RE: Drainage water Plain Street-Beaver Dam Brook,

**Re: Final Engineering Review
WRPD Application – Plain Street Drainage Outfall
ADE Project #2518.43**

RE: A&M Project # 1830-01B
WRPD Application
Plain Street Drainage Outfall
Response to Peer Review Comments

DRAWING TITLE: DRAINAGE MODIFICATION PLAN
SHEET NO. C-1

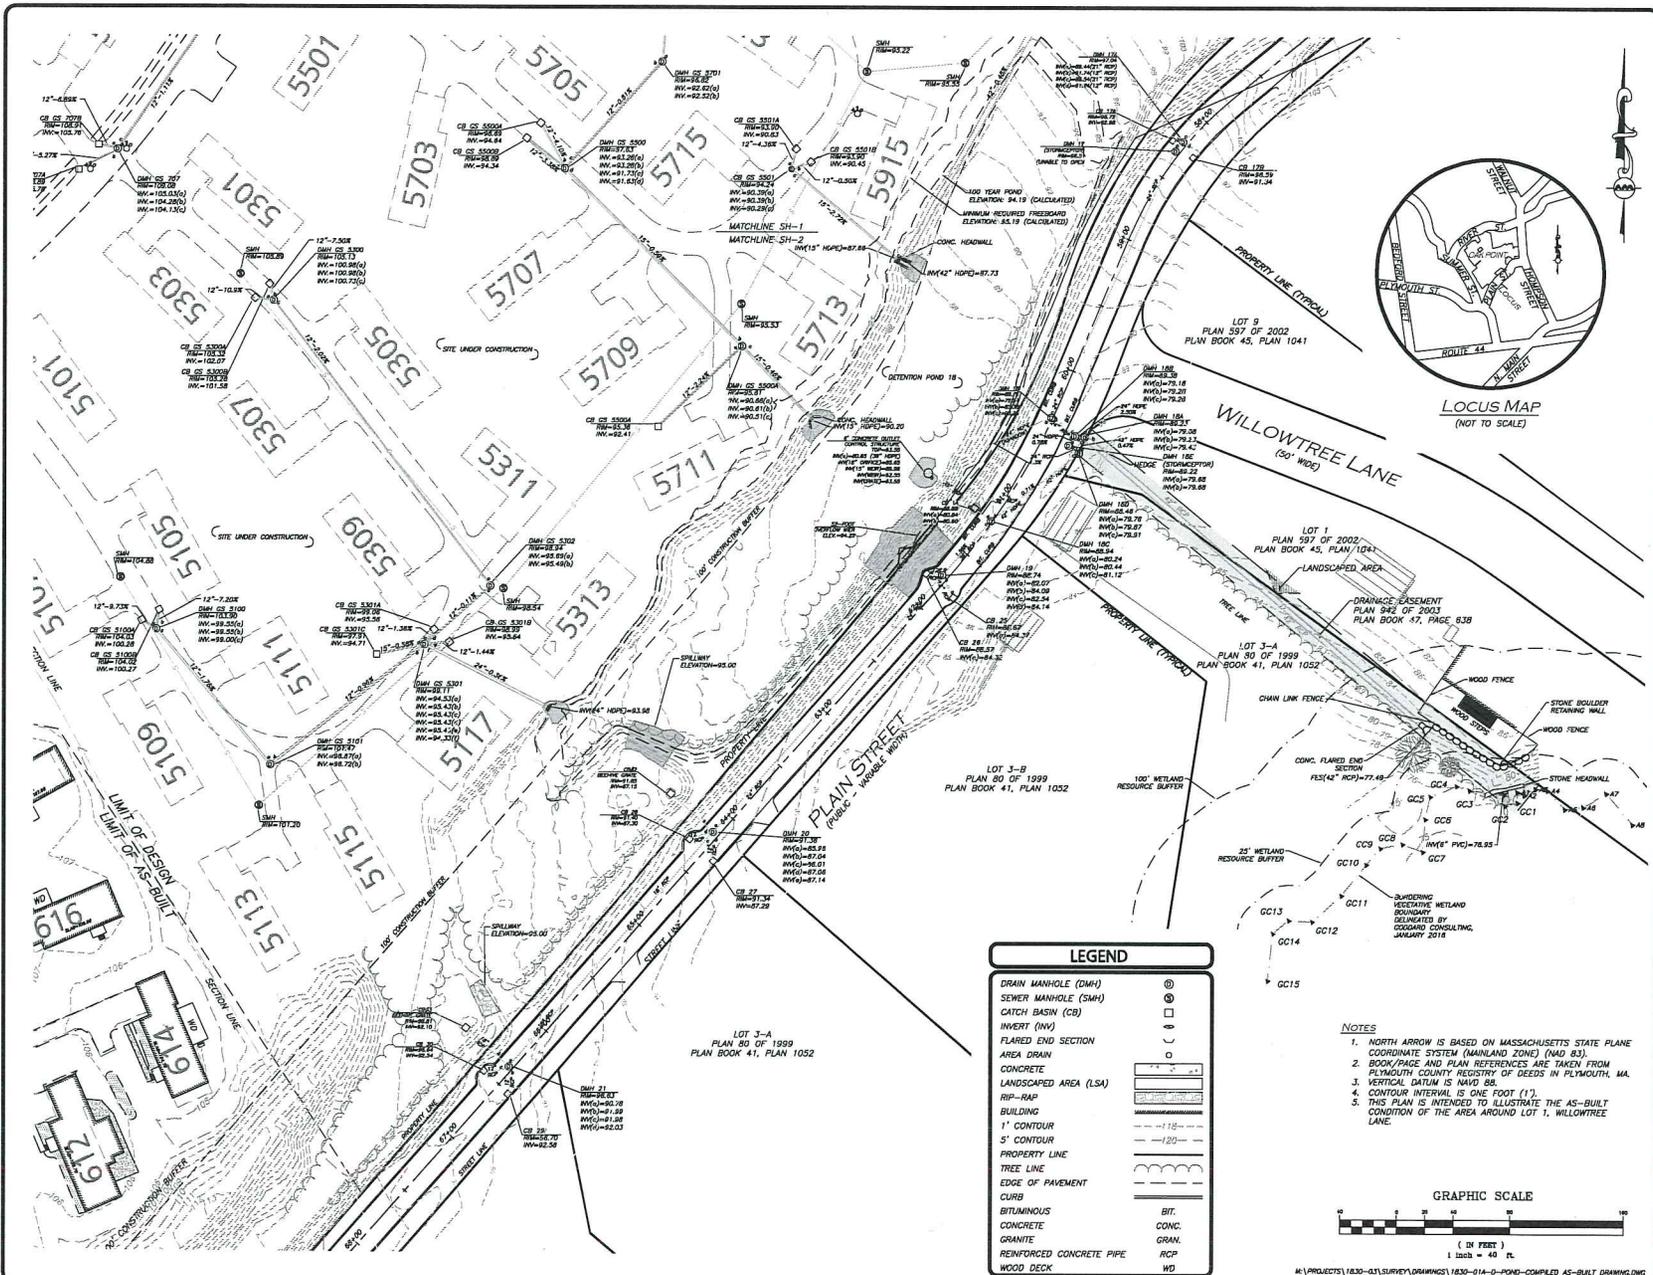
Comment 3: It is recommended that erosion protection/rip-rap be provided at the roof drain outfall from the adjacent dwelling. It appears to be just daylighting onto a proposed 3:1 slope.

Comment 4: It is recommended that the rip-rap at the new box culvert outfall be flared out in front of the wing wall to the northeast and also be extended around the side of the box culvert to the southwest.

Comment 7: Provide a detail for the wing wall. Also, it is recommended that the wing wall be extended to the existing retaining wall. It appears there is a 2' – 3' gap between the walls?

Response 3: The plans have been revised as requested.

Response 4: The plans have been revised as requested.

Response 7: The wing wall is a precast section that will be attached to the end of the box culvert. Shop drawings will be provided by the manufacturer prior to fabrication. The wall has been extended as requested.

10.5 FT. x 6 FT. PRECAST CONCRETE BOX CULVERT
NOT TO SCALE

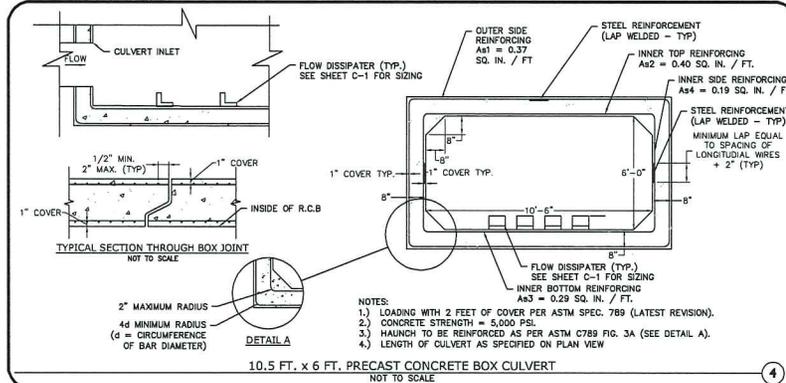
Comment 5: Provide a detail for the connections of the 42" pipe to the box culvert.

Comment 9: The slope of 0.0055 used in the calculations for the box culvert roughness element is the slope of the 42" inlet pipe, not the slope of the box culvert. Does this affect the design?

Comment 10: Section 7.2.2 on Page 7-27 of the FHWA design guidelines appears to recommend that the initial roughness element row be larger (twice the height) than the rest of the element rows. Confirm whether this should apply to this design.

Response 5: The 42" pipe will be mortared to the box culvert to provide a watertight connection.

Response 9: The calculations have been revised accordingly.

Response 10: The increased size of the initial roughness element is only a recommendation and not a requirement, therefore left to the discretion of the design engineer. The proposed design accomplishes the intent of the regulation which is to reduce the velocity to an acceptable value.
